**Panel Report**

**Apollo Bay Tourism Resort Call In  
Colac Otway Permit Application No PP169/2017-1**

**13 December 2018**

Panel Report pursuant to sections 97E, 153 and 155 of the Act

**Figure 3** Cross-sectional view of hotel building

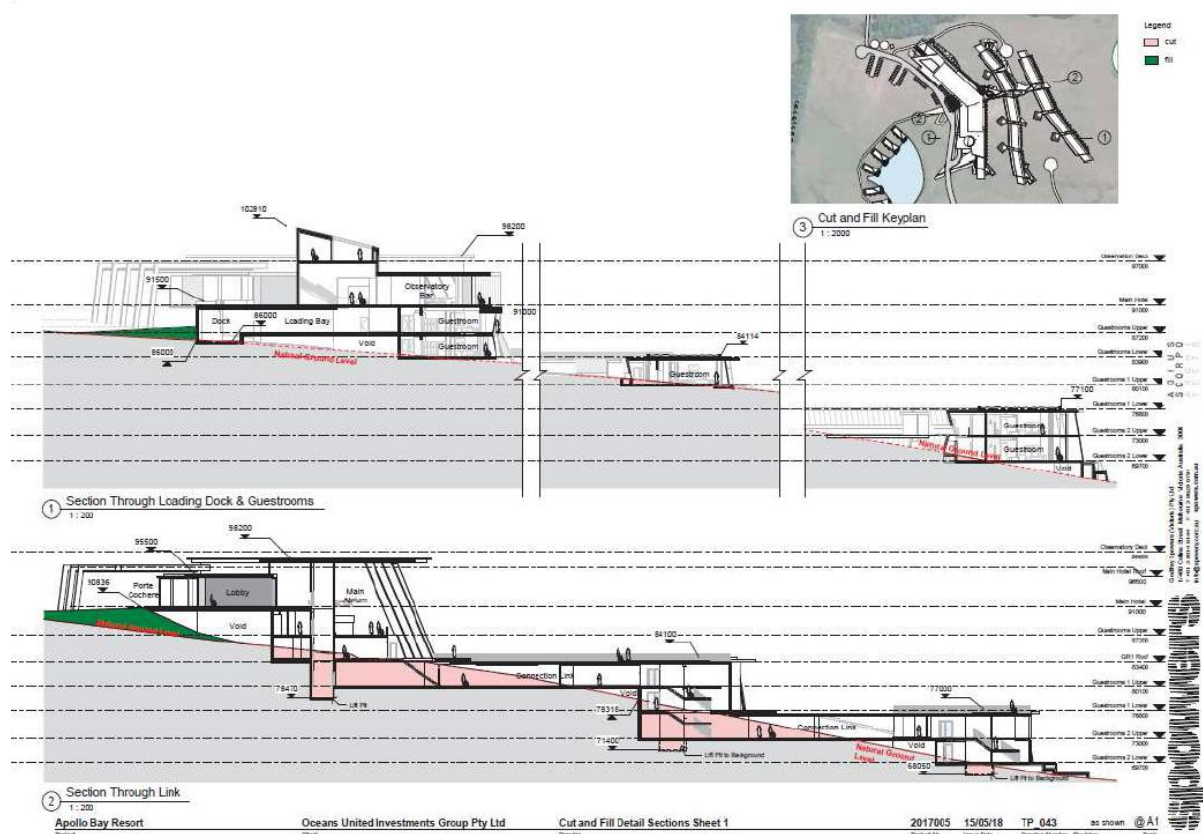
- The scale of the proposed hotel land use cannot be sustained within the Rural Activity Zone given the particular context of the site. Although the hotel building would be articulated and stepped to address site topography, its proposed built form would be contrary to planning policy and would have an unacceptable impact on a nationally recognised landscape. It would also detract from the valued character of the Barham River Valley.

**Figure 8** Map of indicative landslide risk to property

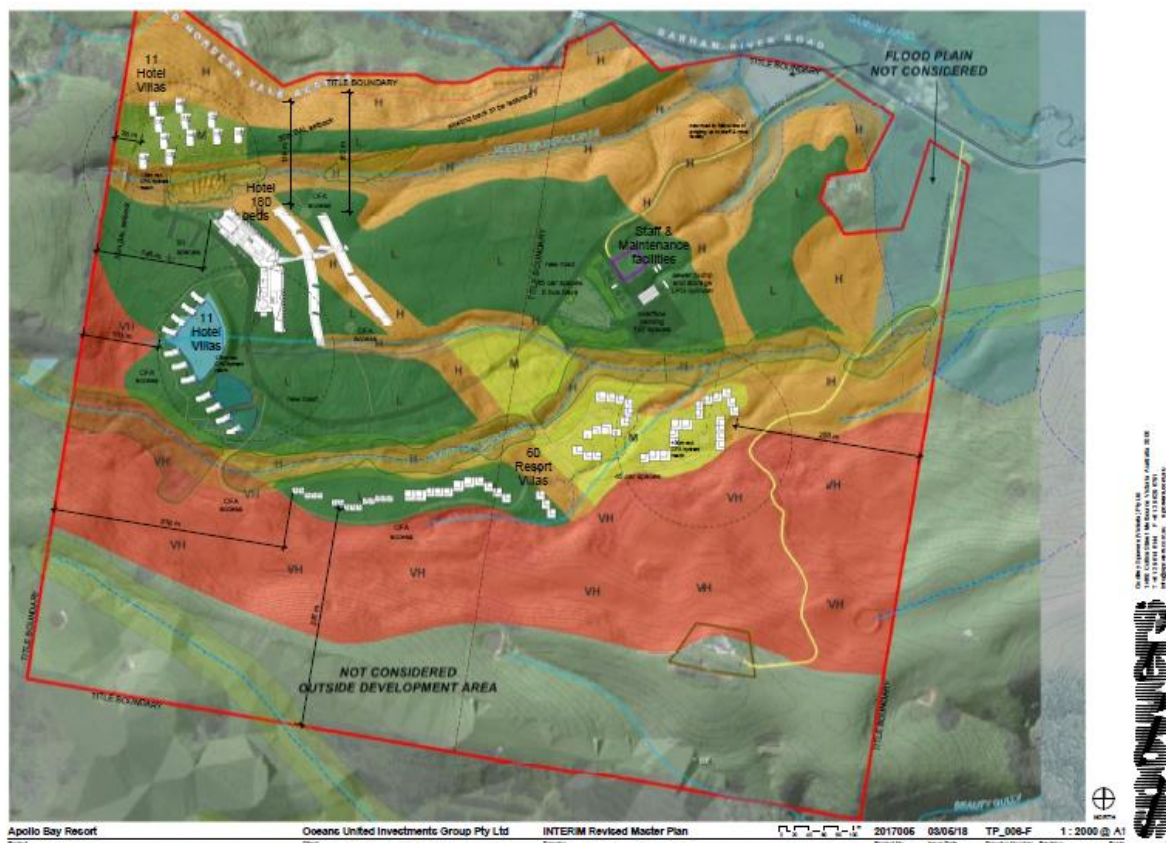
Golder Associates undertook qualitative assessments of risk to property for the initial and amended development proposals in accordance with AGS 2007.<sup>52</sup> It presented a map of indicative risk zones to buildings (Figure 8). It noted that the risk zones shown on the plan are “approximate”.<sup>53</sup>

**Figure 10** Ecological features and vegetation requiring removal or modification to comply with defensible space requirements

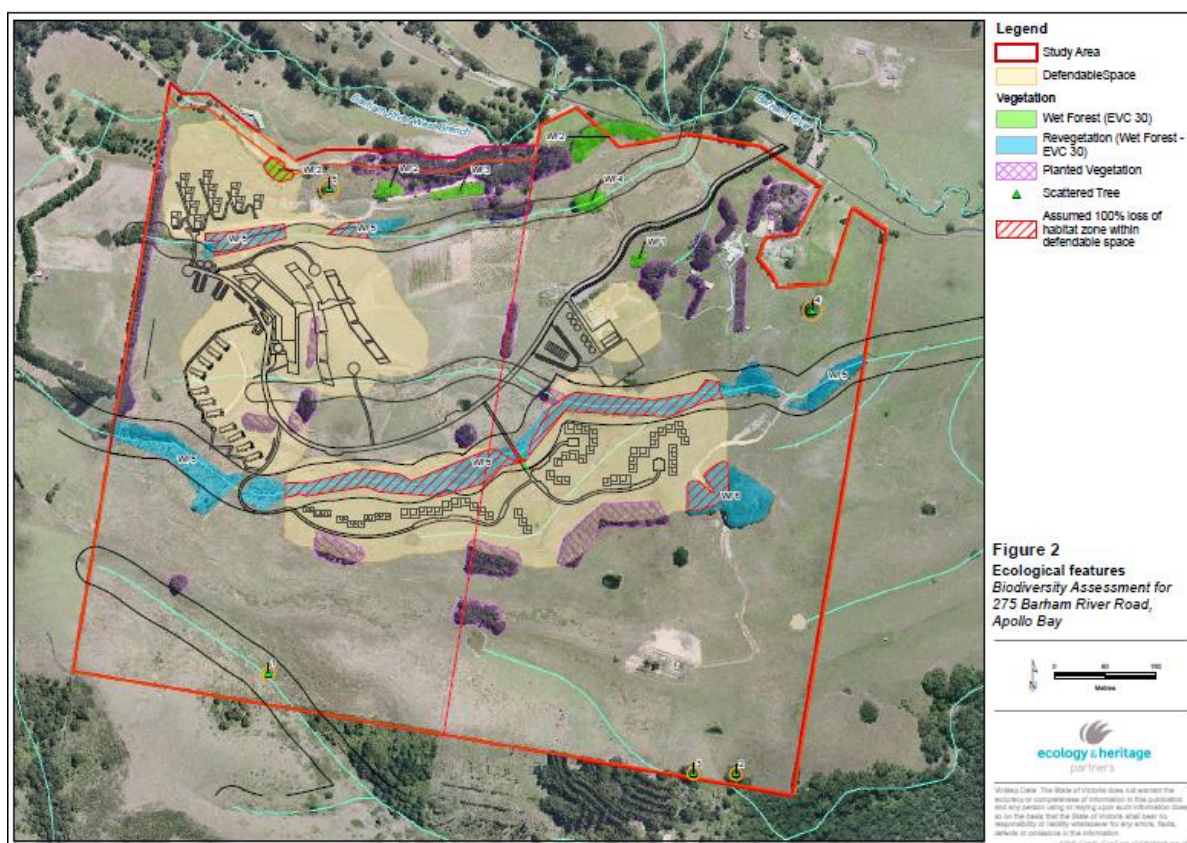
The biodiversity report indicates that the provision of defensible space as shown in Figure 10 will lead to extensive modification or loss of revegetated Wet Forest, particularly along the waterways. This vegetation is not 'remnant' but revegetation planted using public funds for biodiversity enhancement purposes, which is not exempt under the planted vegetation exemption in Clause 52.17.

**Figure 11** Subject property showing the approximate location of designated waterways

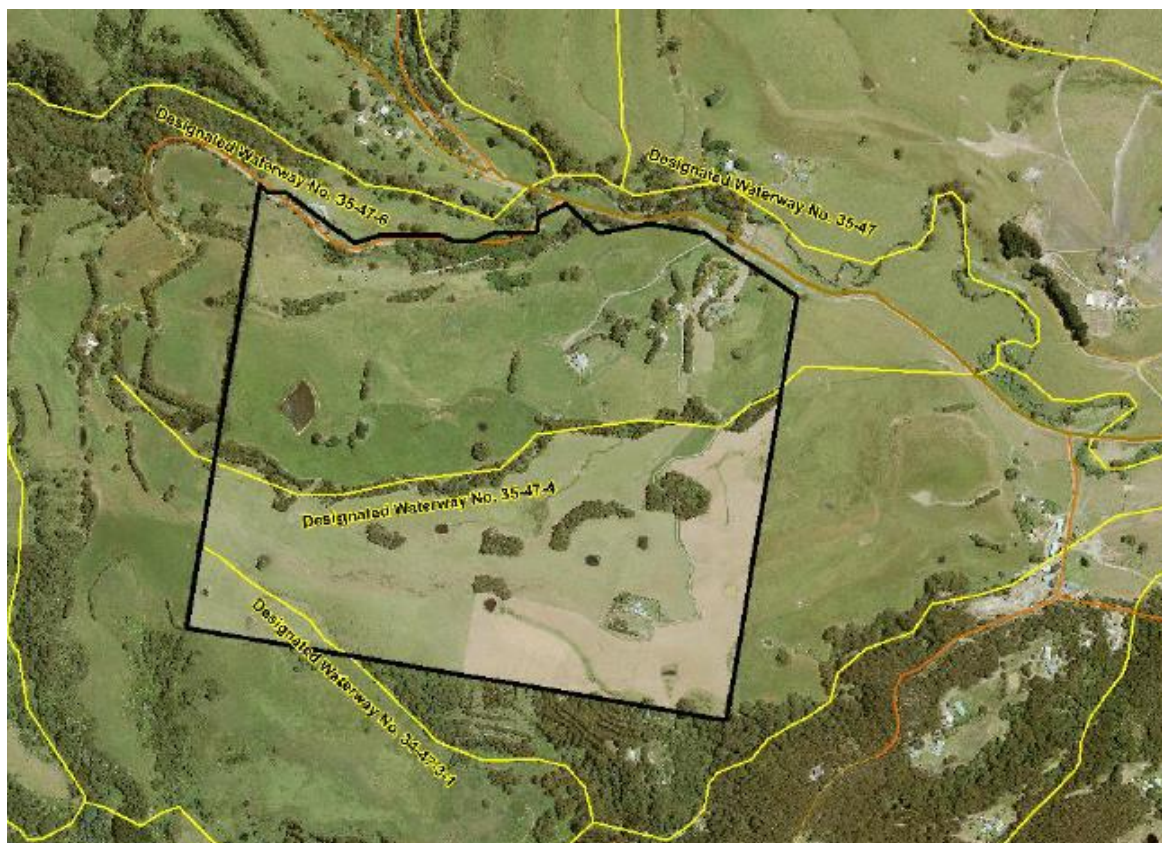
CCMA indicated that two of the waterways traversing the property have been designated under the *Water Act 1989*, and provided a map showing the location of these waterways (Figure 11). A Works on Waterways permit application must be submitted to CCMA prior to any works in, on, or over these waterways, and be approved prior to the commencement of works. Such works include any access crossings (temporary or permanent) and stormwater outlets.
